MOUNT POLLEY MINING CORPORATION

Re: Geotechnical Inspection Report, September 24, 2012

REPORT OF GEOTECHNICAL INSPECTOR

Name of Property: Mount Polley Mine **Permit No.:** M-200

Photo 6: TSF. Stage 8 till and filter construction. To facilitate compaction till is placed at 2:1 slope beyond line then trimmed back.

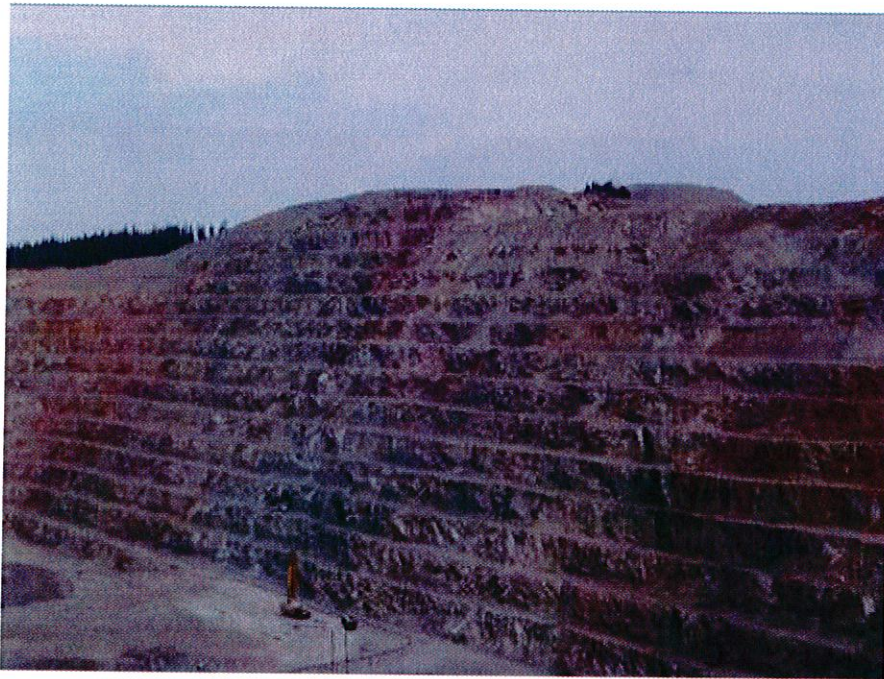
The Stage 8 dam raise to elevation 963.5m was underway at the time of this inspection. EMNG has previously reviewed and accepted the designs for this lift. We reviewed placement procedures for the till core and filters, see Photo 6. We also observed sand cell construction on the upstream side of the west dam and discussed the problems and potential impacts of limited sand placement on the central dam due to gravity placement limitation, it is understood that the Mine's consultants (AMEC) will be reviewing. We also inspected the keyway tie in on the South Dam. All construction appears to be well done. A quality control and quality assurance program is in place and it is understood that there have been no significant issues. The Mine reports that instrumentation has responded as expected during construction. It was noted that some of the instrumentation is not well protected from potential construction equipment damage and recommend that this be remedied.
